SOLACE OF COLORADO SPRINGS

PHASE 1 - SITE DEVELOPMENT PLAN

Site Development Plan_V2.pdf Markup Summary

LOT 1 SITE PLAN NORTH

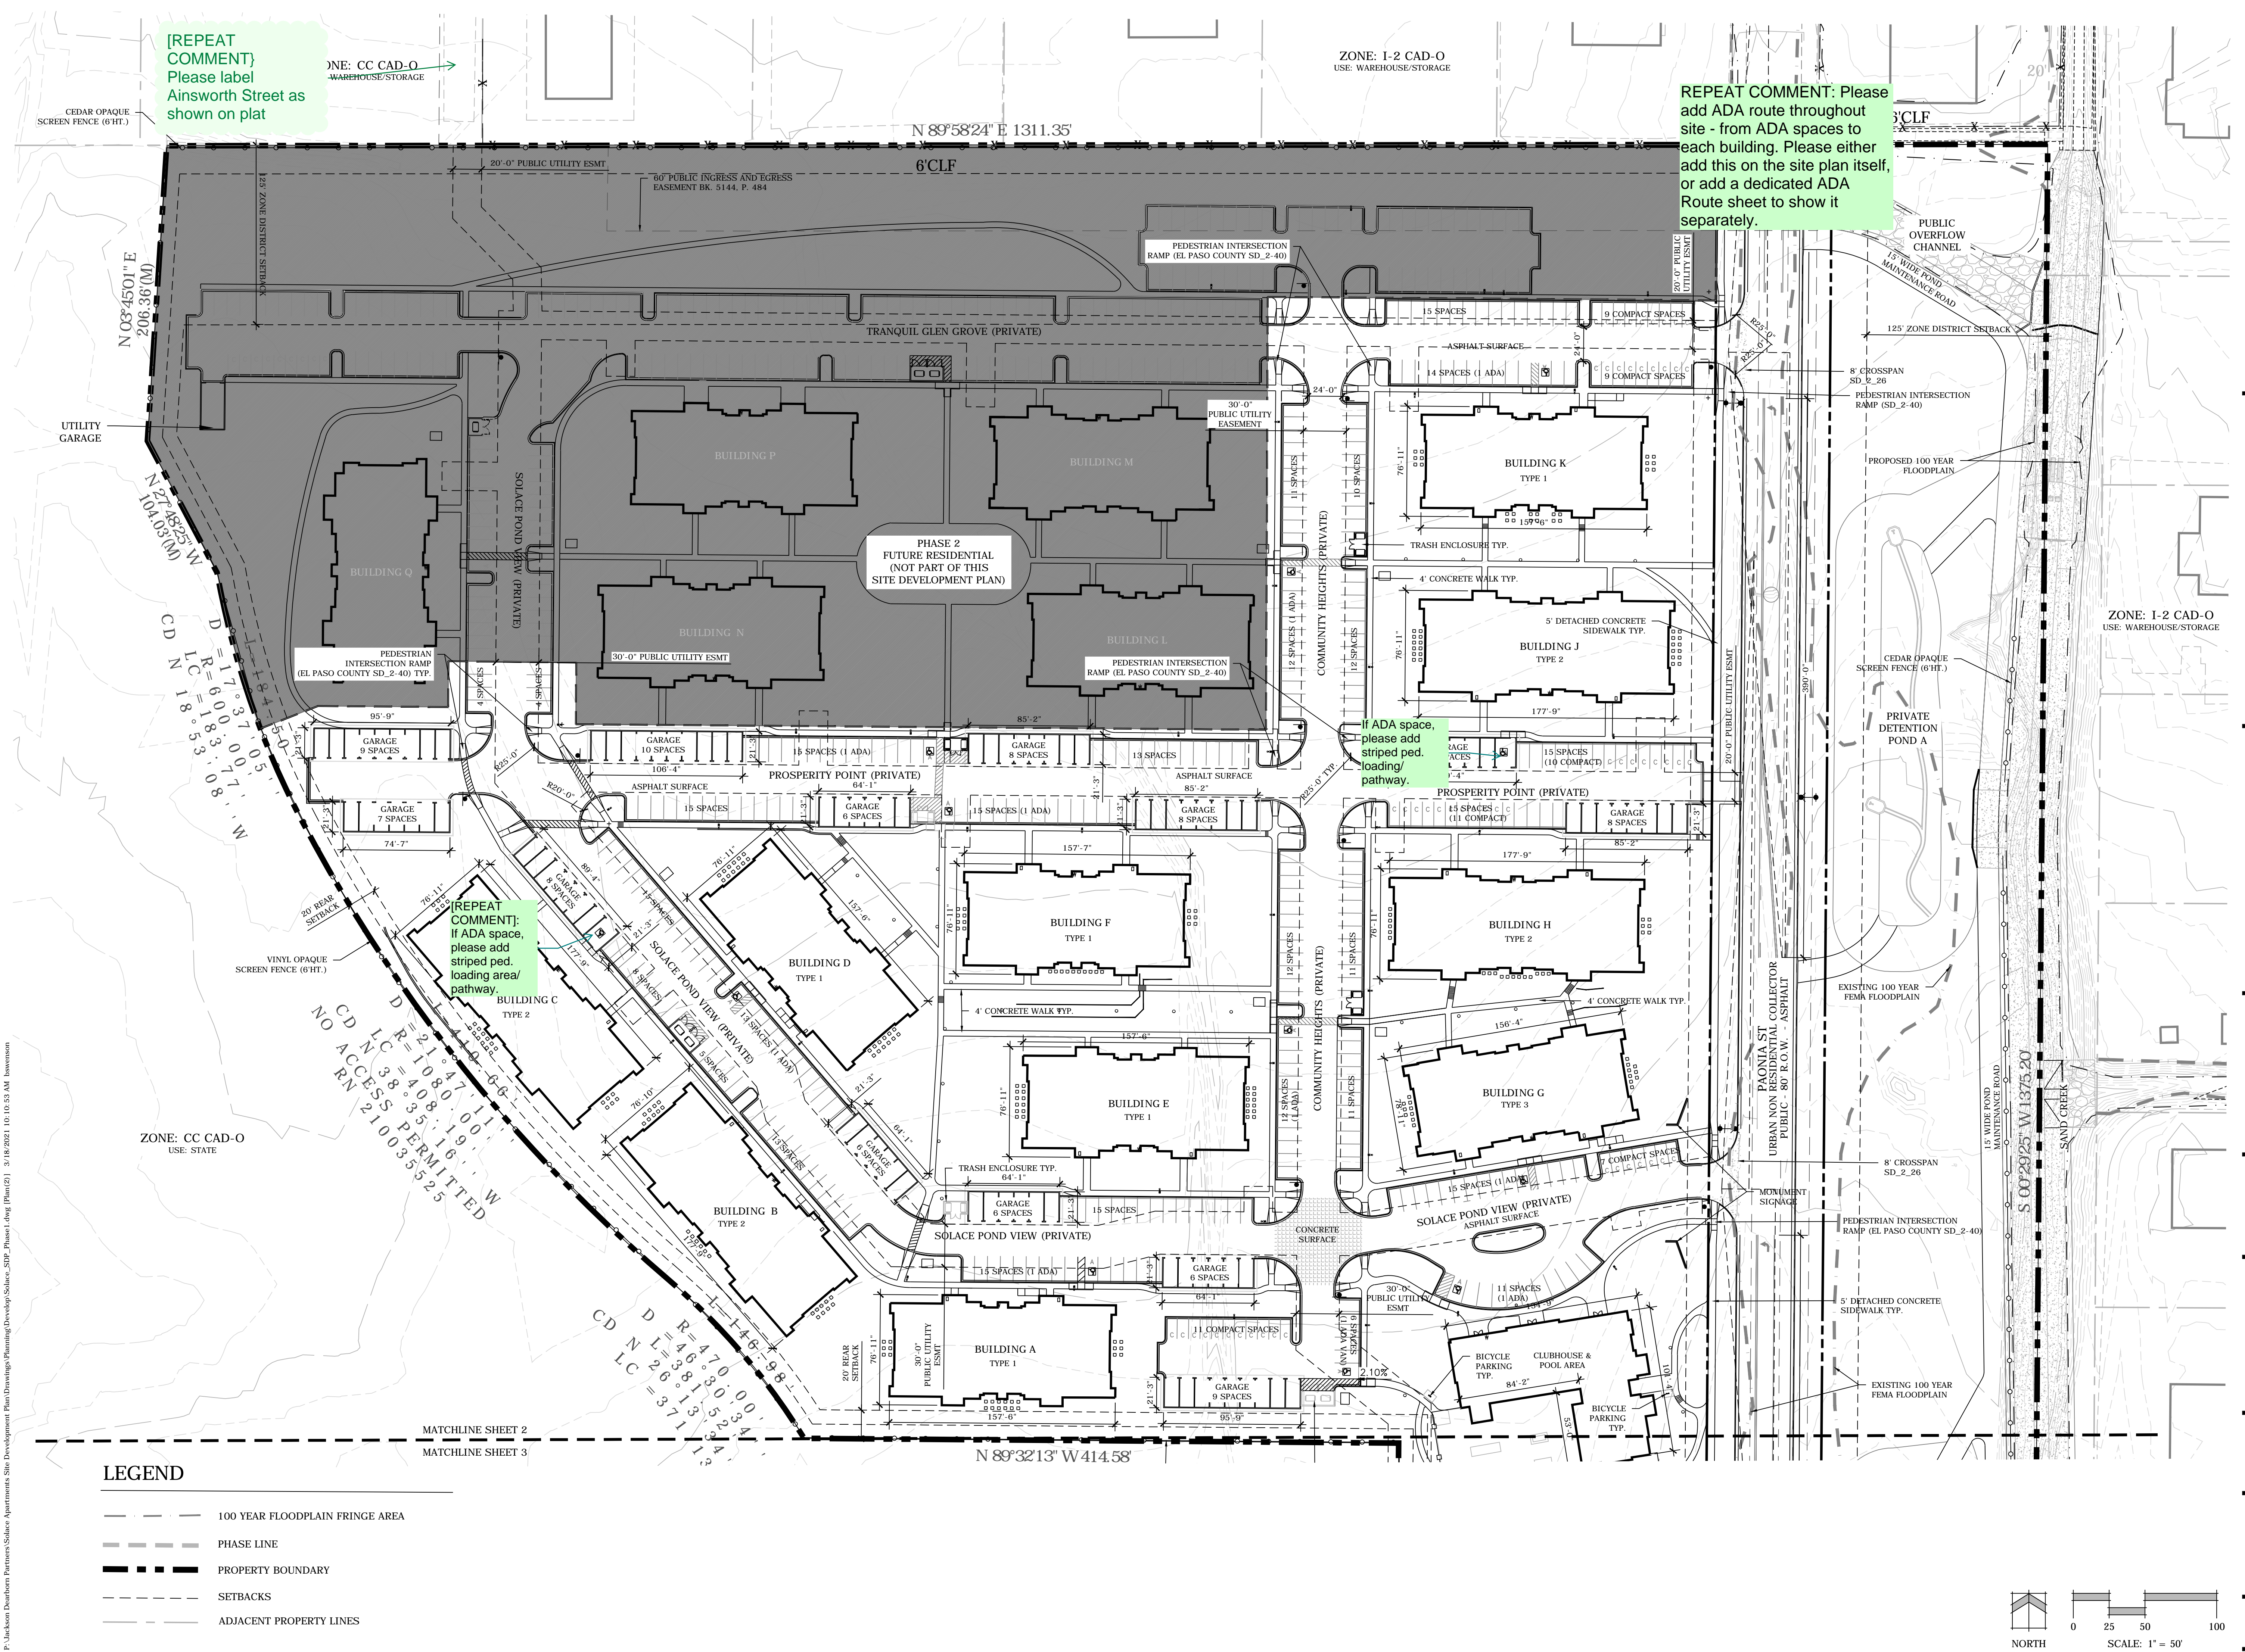
[REPEAT COMMENT]
Please label Ainsworth Street as shown on plat

[REPEAT COMMENT]:
If ADA space, please add striped ped. loading area/ pathway.

If ADA space, please add striped ped. loading/ pathway.

REPEAT COMMENT: Please add ADA route throughout site - from ADA spaces to each building. Please either add this on the site plan itself, or add a dedicated ADA Route sheet to show it separately.
